BEFORE THE BOARD OF COUNTY COMMISSIONERS
OF LANCASTER COUNTY, NEBRASKA

IN THE MATTER OF CHANGING)
THE DETOUR PLAN FOR PROJECT) RESOLUTION NO. R-10-0086
NUMBER C55-S-401(6))

DETOUR PLAN FOR PROJECT NO. C55-S-401(6)
S. 68th Street Viaduct

REVISED DETOUR PLAN FOR PROJECT NO. C55-S-401(8)
~~DETOUR PLAN FOR PROJECT NO. C55-S-401(6)~~
 S. 68th Street Viaduct

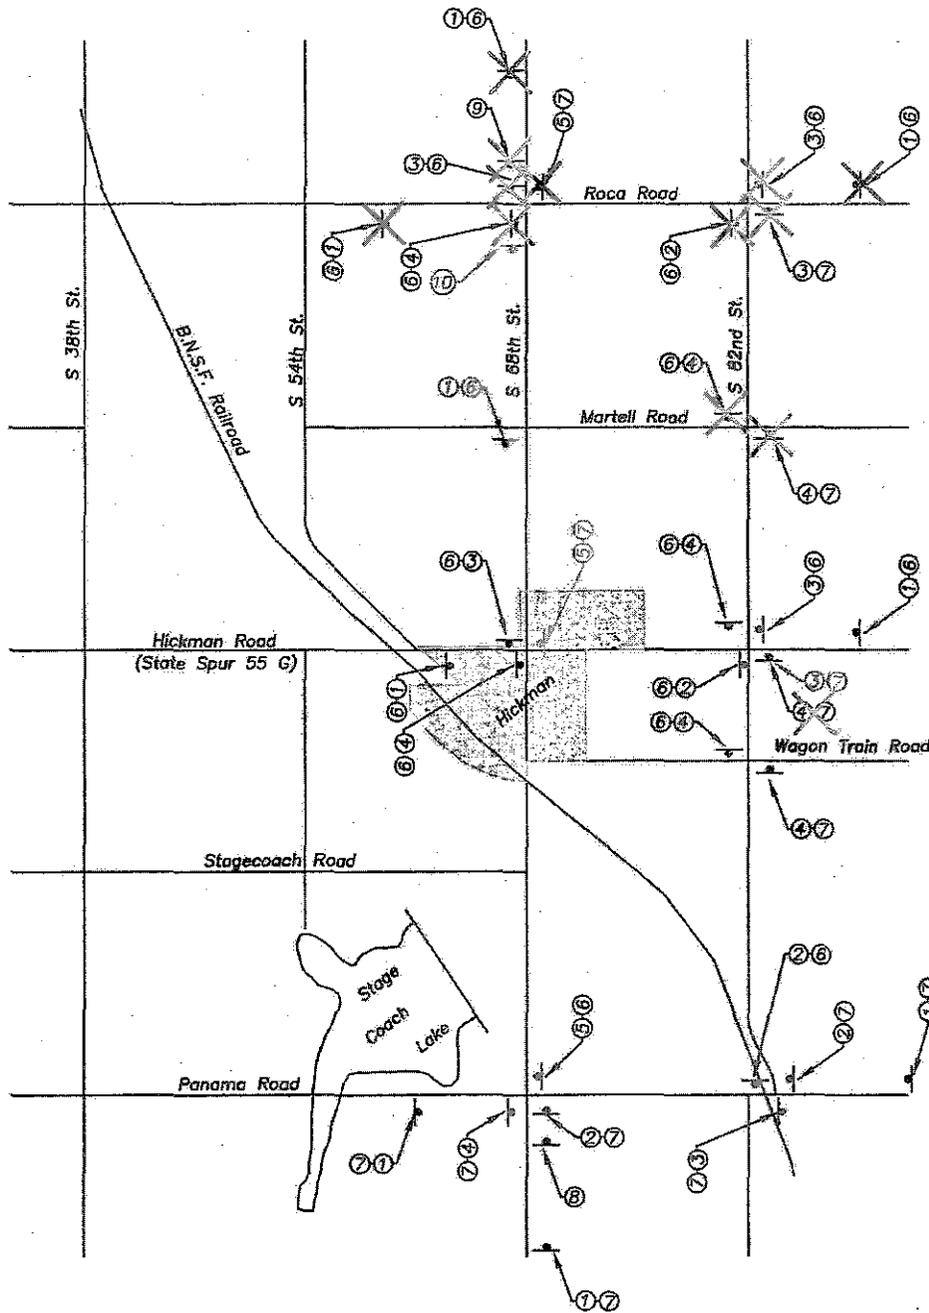
WHEREAS, the Board of County Commissioners of Lancaster County has since determined it in the interest of nearby businesses to revise the detour route, as provided in Exhibit "B," attached hereto and incorporated by this reference; and

WHEREAS, the County Board is agreeable to the proposed Revised Detour Plan for Project No. C55-S-401(6), as provided in Exhibit "B".

NOW, THEREFORE, BE IT RESOLVED, by the Board of County Commissioners of Lancaster County, that the Revised Detour Plan for Project No. C55-S-401(6), as provided in Exhibit "B," is hereby adopted and shall become effective on September 28, 2010.

- ① "Detour Ahead"-(W20-2A)
- ② "Detour"- Right Arrow (M4-9R)
- ③ "Detour"- Left Arrow (M4-9L)
- ④ "Detour"- Straight Arrow (M4-9S)
- ⑤ "End Detour"-(M4-8A)
- ⑥ "S. 68th St. South" *
- ⑦ "S. 68th St. North" *
- ⑧ "Road Closed 1/2 Mile Ahead Local Traffic Only" (R11-3)
- ~~⑨ "Road Closed 2 Miles Ahead Local Traffic Only" (R11-3)~~
- ⑩ "Road Closed 2 Miles (W20-3G)
